MITSUBISHI ELECTRIC Inverter

No. 637E

Appearance Change of the General-Purpose Inverter Option FR-XCB Reactor

FR-XCB-18.5K to 55K, FR-XCB-H18.5K to H55K

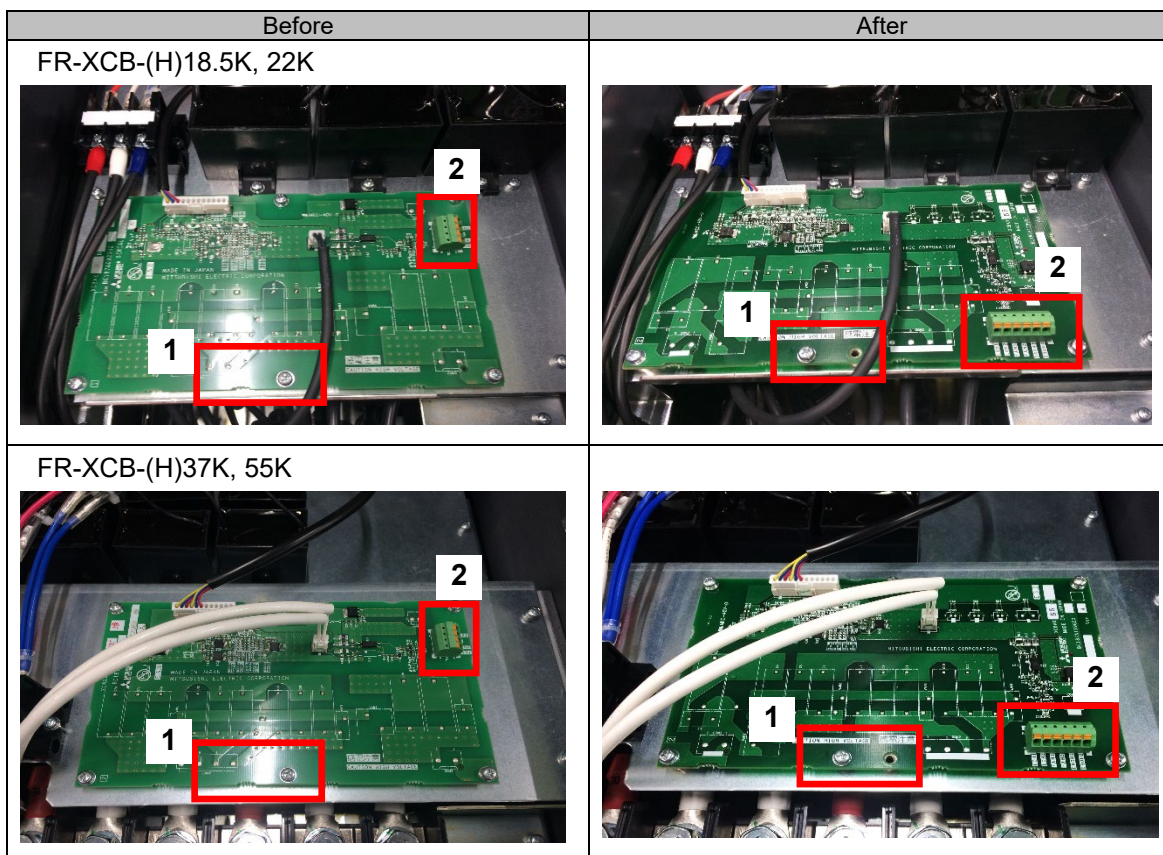
1. A screw hole will be added in the area 1 outlined in red.
2. The position of the control circuit terminals will be changed as shown in the area 2 outlined in red.
 Control circuit terminals DROH1 and DROH2 will be added. (They are not used in the FR-XC-(H)55K or lower.)
